ALLEGHENY COUNTY SANITARY AUTHORITY

CONTRACT NO. 1729 G, E, H, P

EAST HEADWORKS

ADDENDUM NO. 6

CDM-01
SITE DEMOLITION PLAN

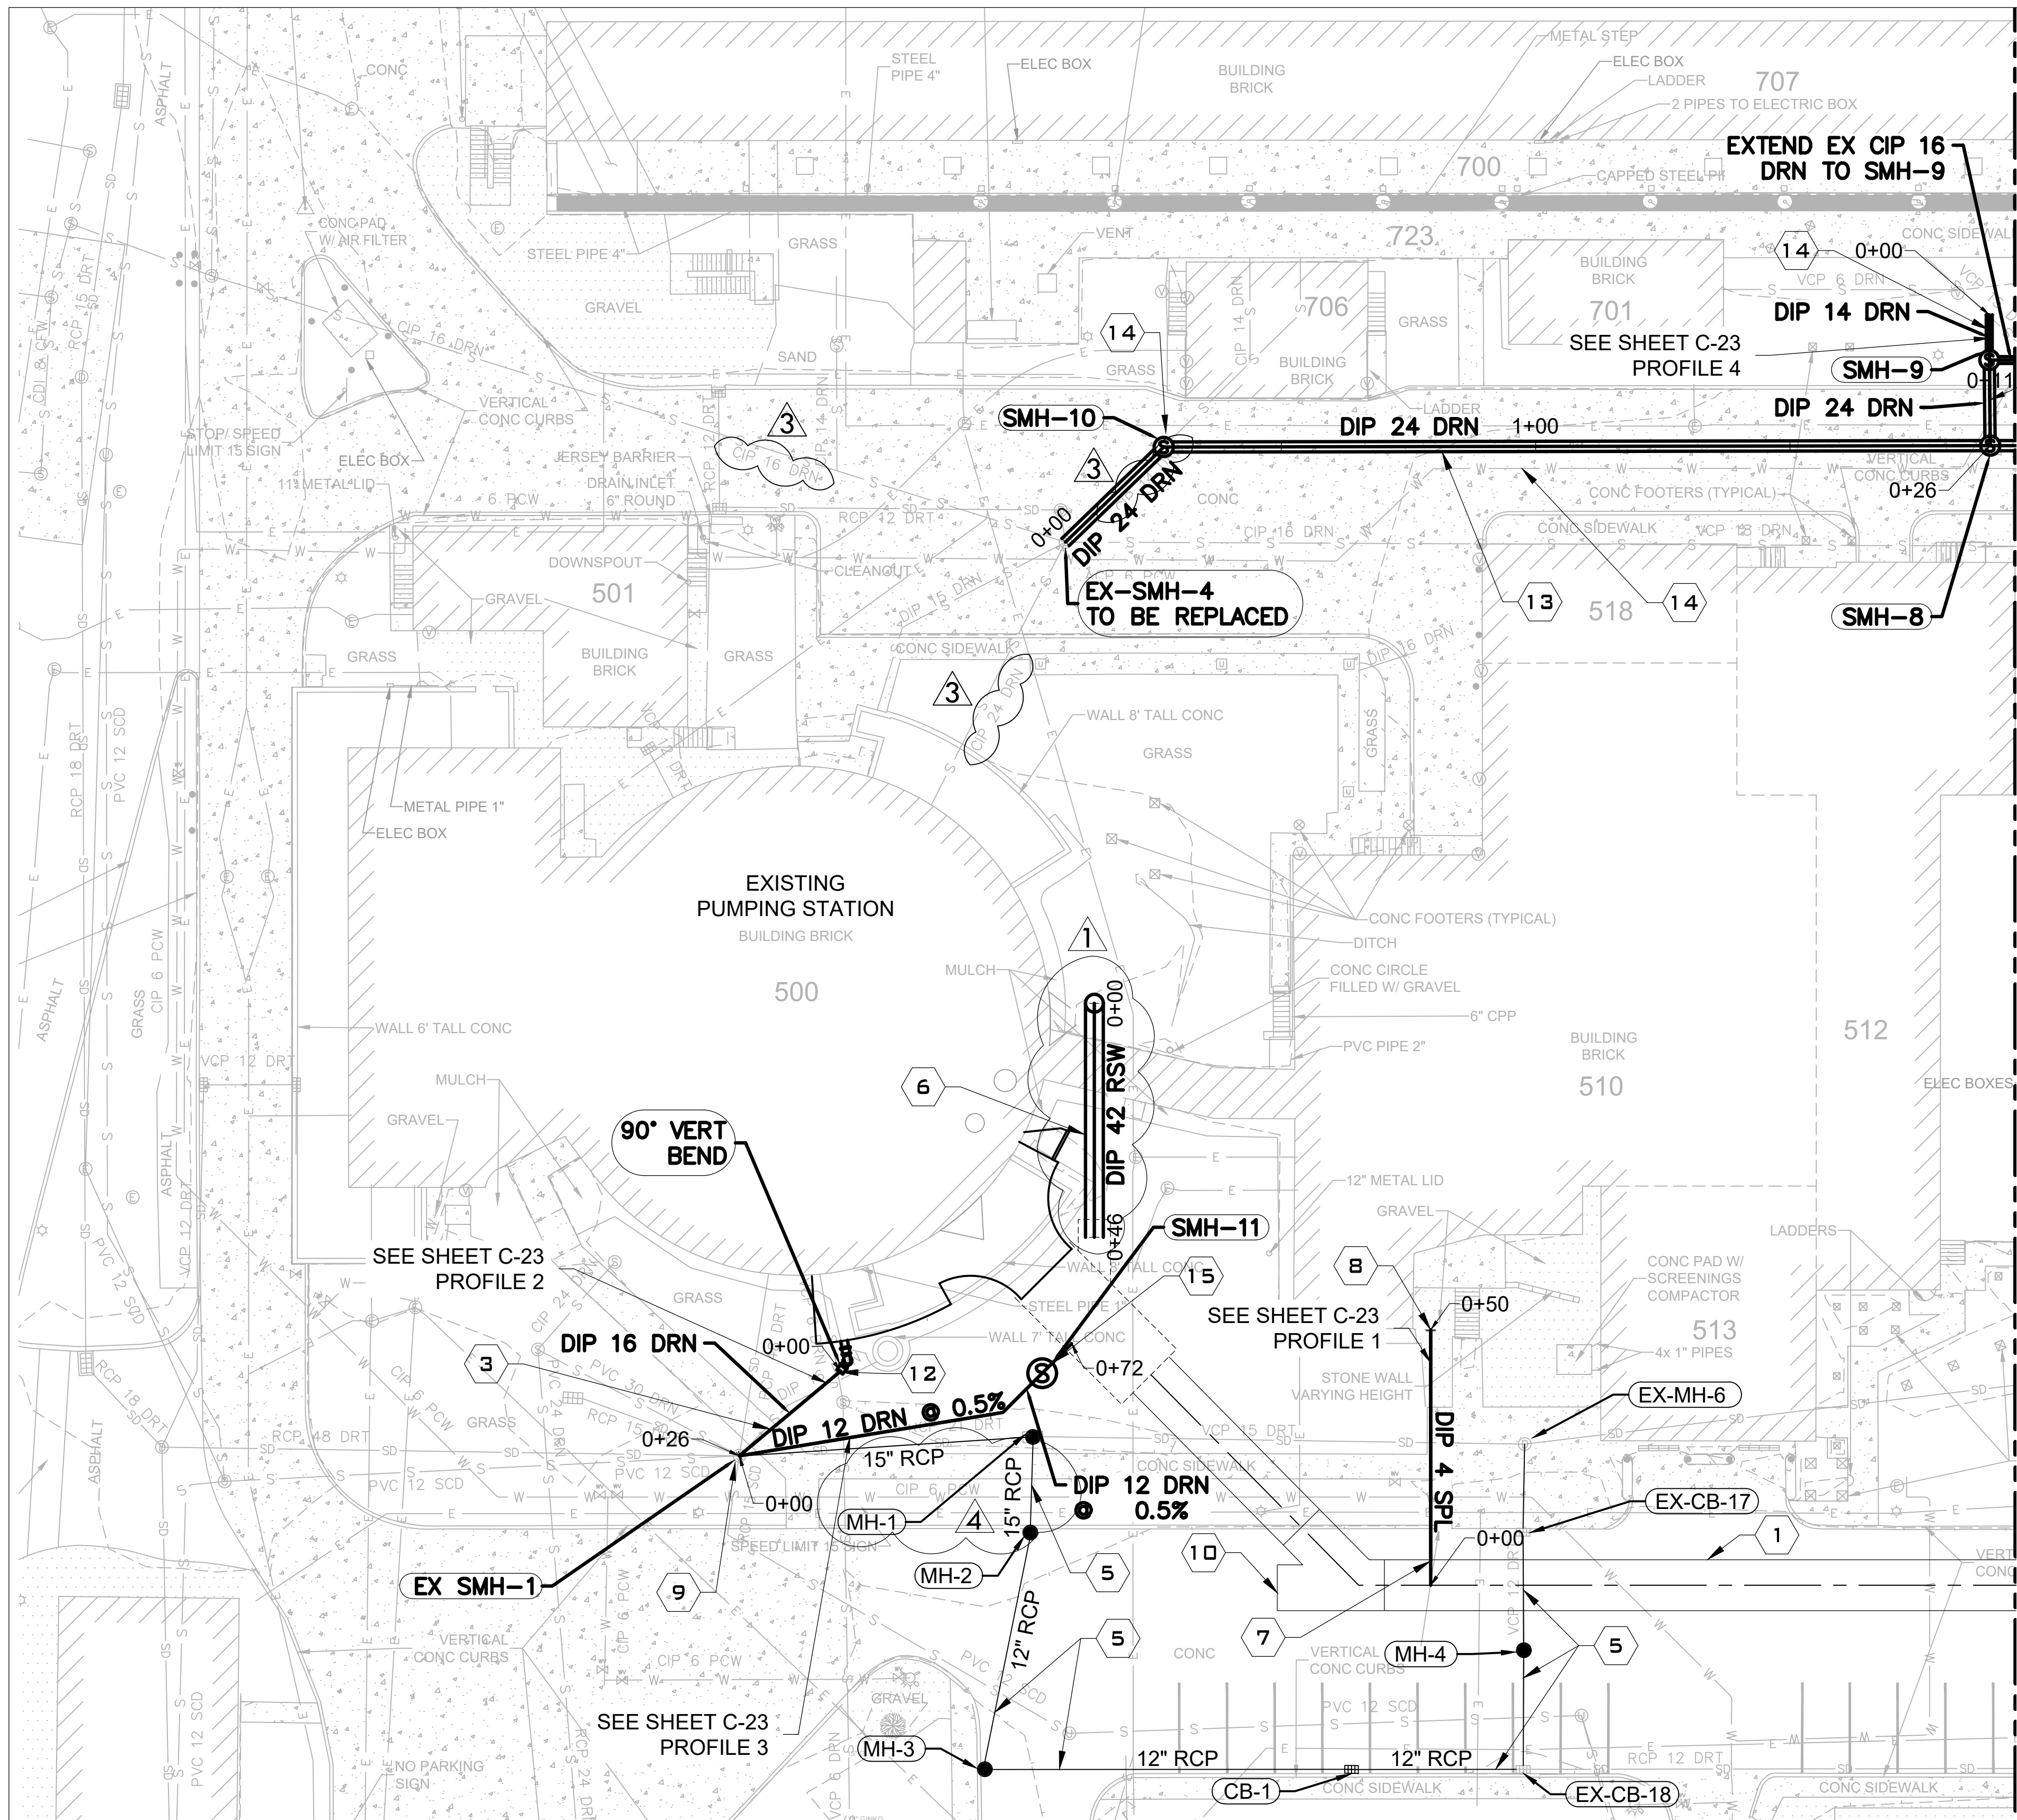
76. QUESTION: On drawing C-03 (31 of 645), CDM-01 (32 of 645) & drawing C-21 (38 of 645) re-issued in Addendum No. 4 an existing ductbank is shown running northwest-southeast along the east side of the existing pumping station (500) and just west of EX SMH-4. On CDM-01 keynote 10 indicates that the ductbank will be abandoned in place. Will the section of the ductbank just west of EX SMH-4 also be abandoned in place?

RESPONSE: The ductbank referred to in the question is the same as referred to in Addendum No. 1, Section 01 52 00, Section 1.7, new paragraph P.1. This ductbank will be abandoned, but not until power is re-fed to Building 510 as part of Contract 1739. New ductbanks are being installed in the general area of EX. SMH-4 as part of Contract 1739. All work in the area of EX. SMH-4 shall be closely coordinated with the Construction Manager and the Contract 1739 Contractor.

C-21
YARD PIPING PLAN - WEST

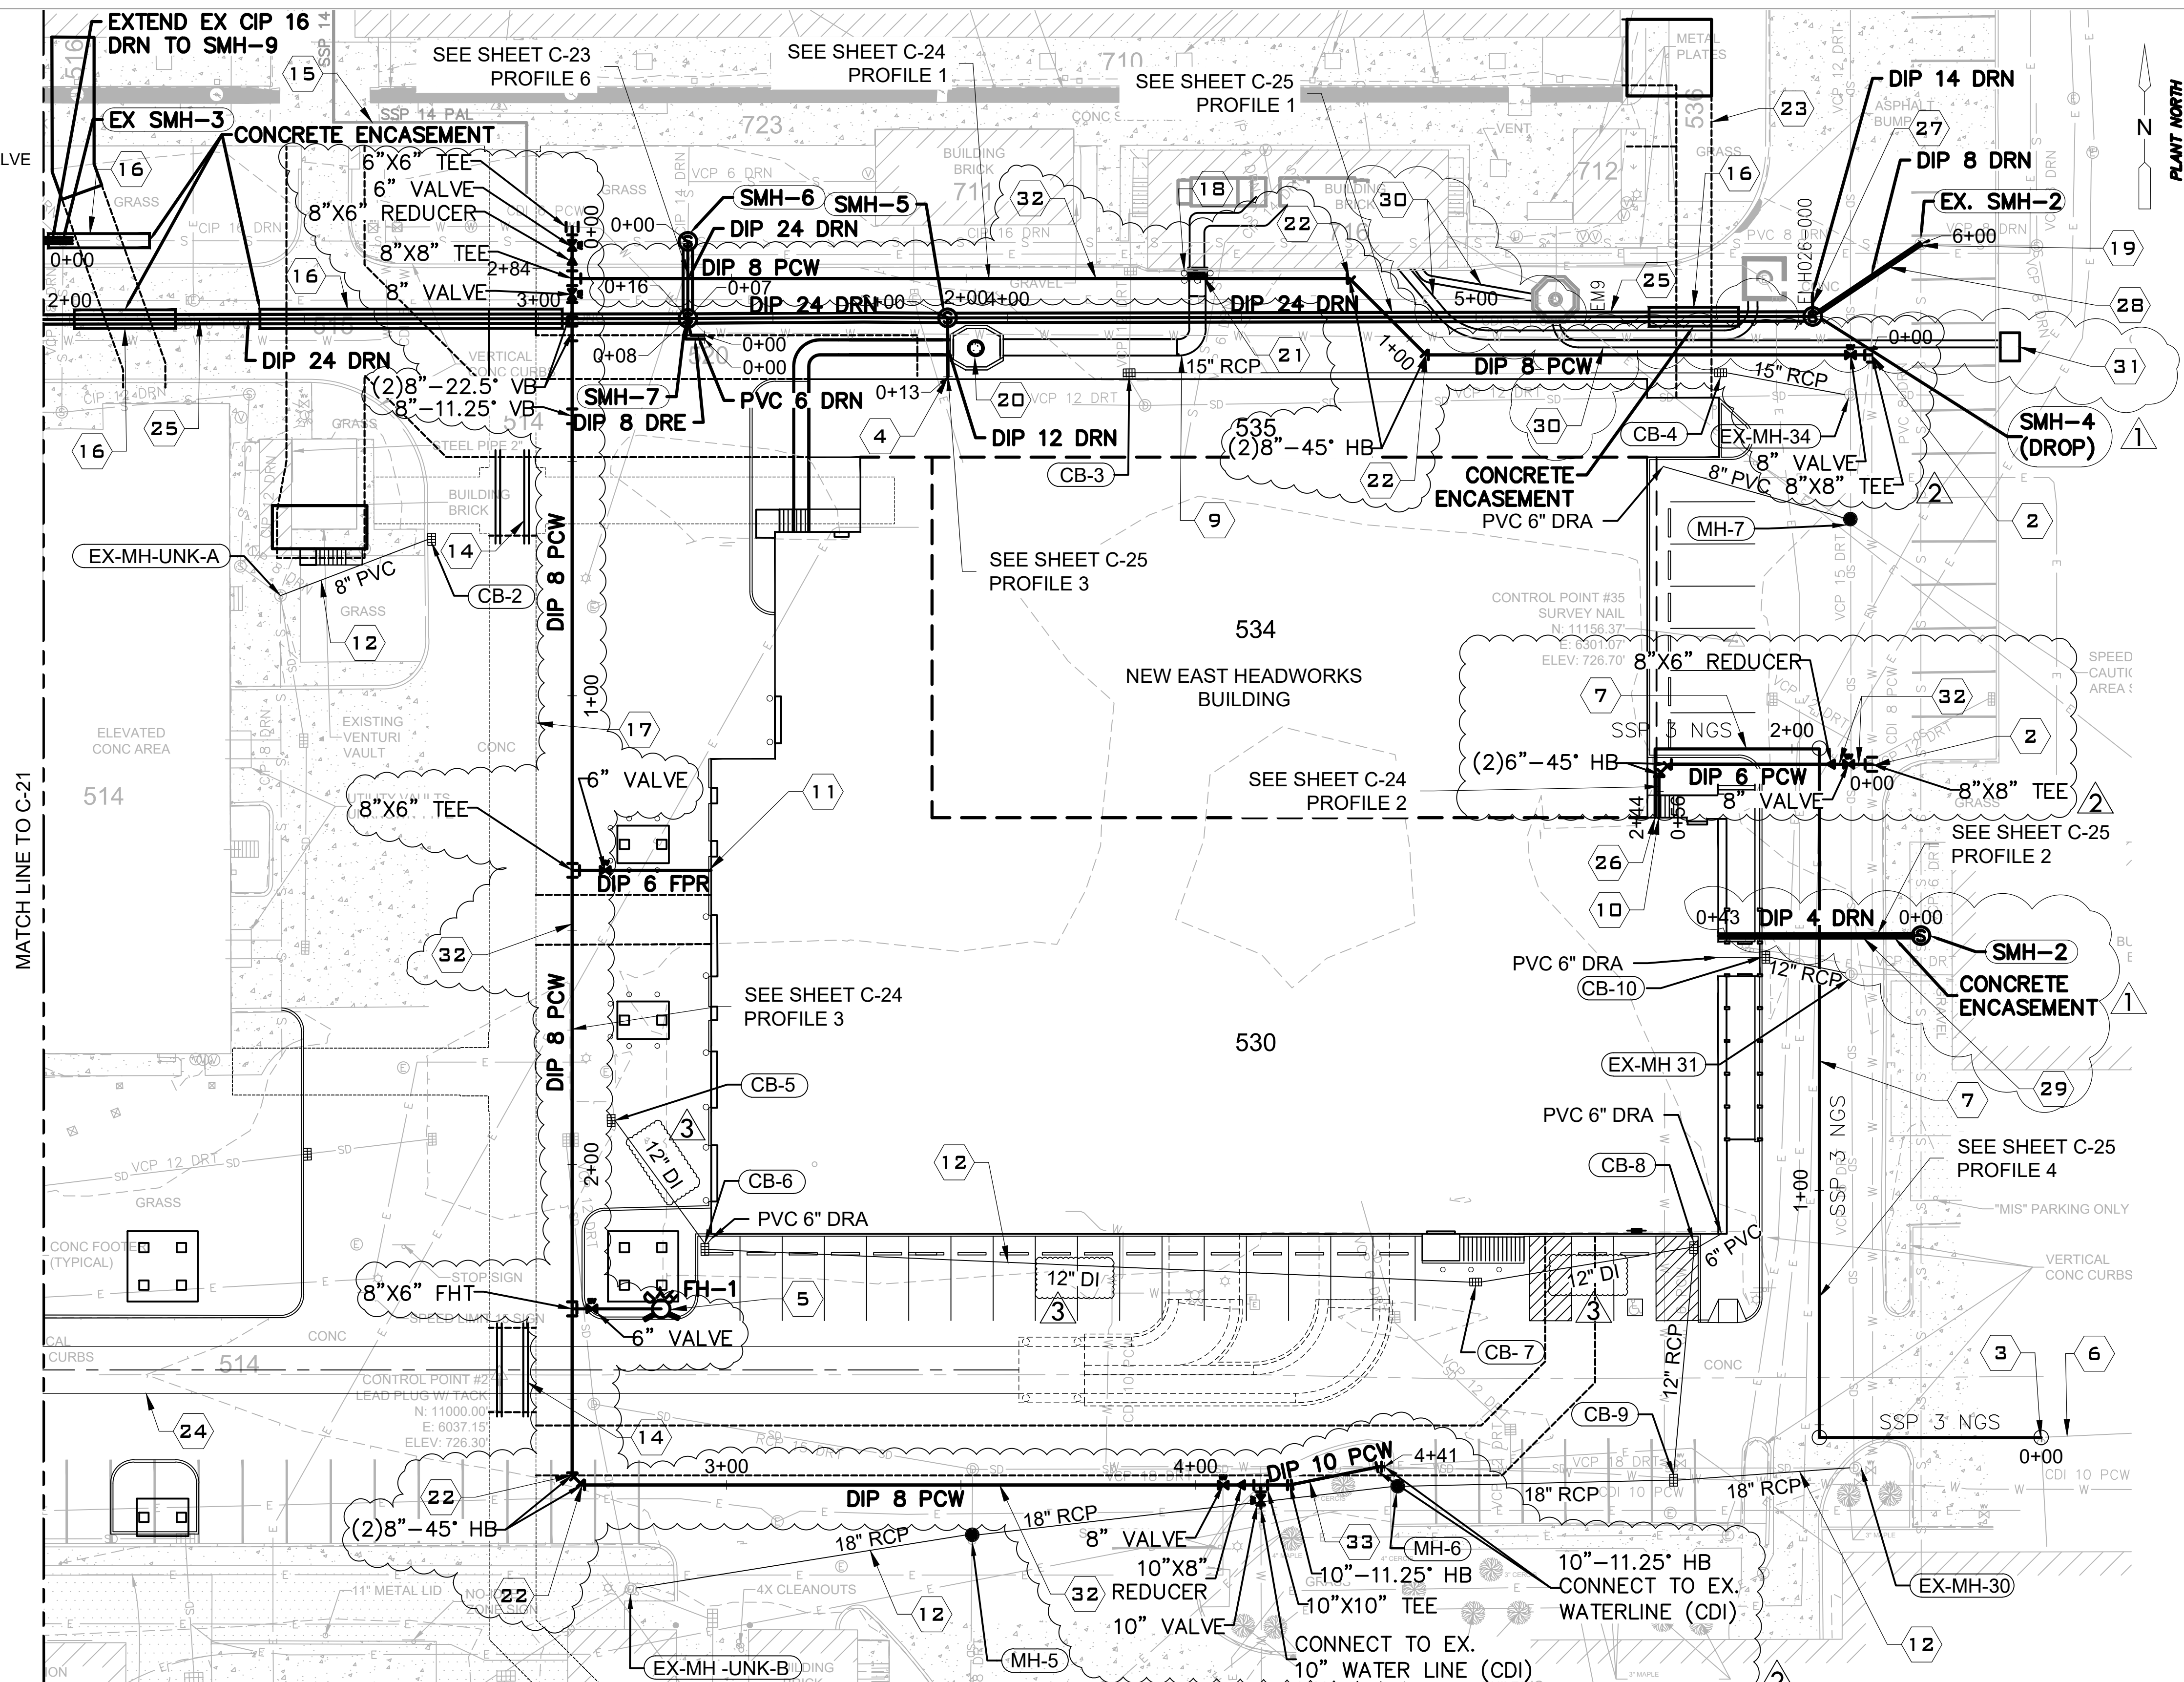
75. QUESTION: Contract drawing C-21 (38 of 645) was re-issued in Addendum No. 4. This re-issued drawing indicates changes to the DIP 42 RSW line and keynote No. 6 that are clouded and labeled as revised in Addendum No. 2. There were no changes to drawing C-21 included as part of Addendum No. 2 when issued on 12/22/2020. Please advise.

79. QUESTION: Reference drawing C-21 (38 of 645) which was re-issued in addendum no. 4 and drawing C-41 (49 of 645). There is a manhole south of the existing main pumping station which is called out as **EX-MH-2** on drawing C-41 and the same manhole is called out **EX SMH-1** on drawing C-21. Please advise.

80. QUESTION: Reference drawing C-21 (38 of 645) which was re-issued in addendum no. 4 shows a 24" line connecting EX SMH-1 to MH-1 and a 12" line connecting MH-1 to MH-2 and both are listed as HDPE. Also reference drawings C-41 (49 of 645) and drawing C-43 (51 of 645) which list the same lines as 15" RCP. Please clarify the line sizes and which pipe material is to be used.

RESPONSE: Drawing C-21 was re-issued in Addendum No. 4 and is being re-issued again in Addendum No. 6. Changes were included in Addendum No. 4 that were erroneously identified as Addendum No. 2 revisions. All changes are valid, however, so bidders shall base their bids on Drawing C-21 as issued in Addendum No. 6 unless otherwise modified in a future addendum.

RESPONSE: EX-MH-2 on Drawing C-41 is referring to the same manhole called out as EX SMH-1 on Drawing C-21.

RESPONSE: 15" RCP is the correct size and material for the referenced lines. Drawing C-21 has been re-issued to correct pipes.

**530-TT-09
EAST HEADWORKS
SECOND FLOOR - PLAN AREA - B**

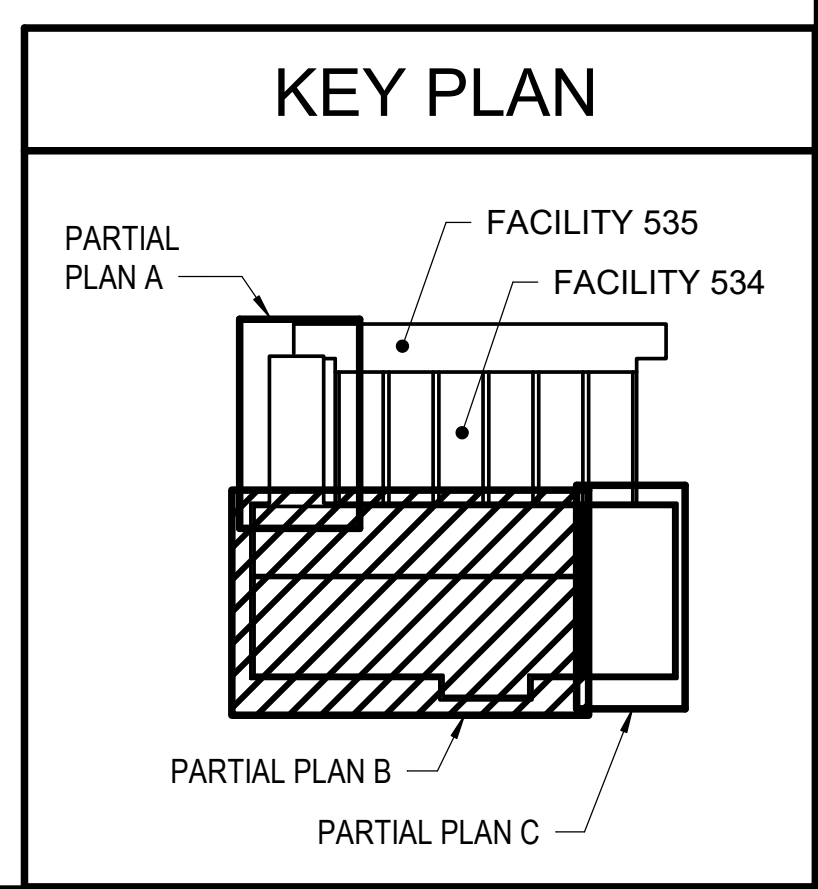
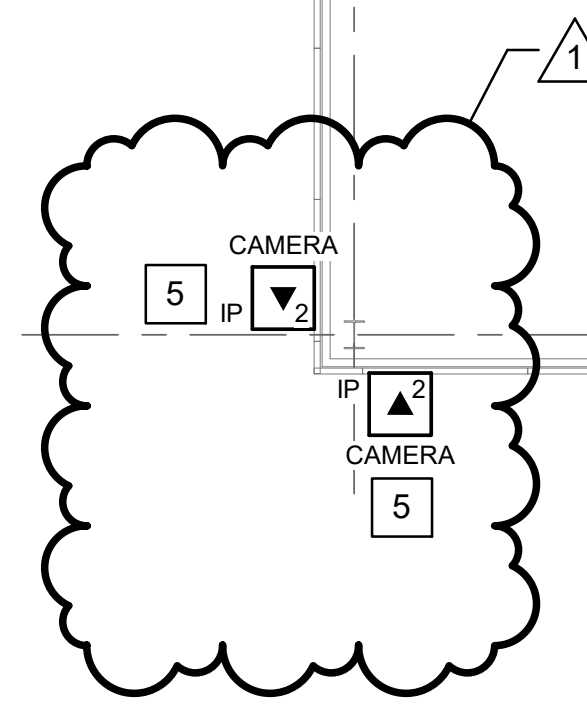
94. QUESTION: Reference Surveillance Cameras – Contract Drawing 530-TR-04 East Headworks Video Surveillance Cam Outlet Cabling: The two cameras in the Truck Access Area are not shown on 530-TT-06, are they meant to be there and in what area of the Truck Access Area will they be positioned?

RESPONSE: See updated drawing 530-TT-09 for Truck Access Area cameras, both are exterior building cameras, one on the west exterior wall and one on the south exterior wall. These are consistent with camera locations shown on Drawing 530-TY-10.
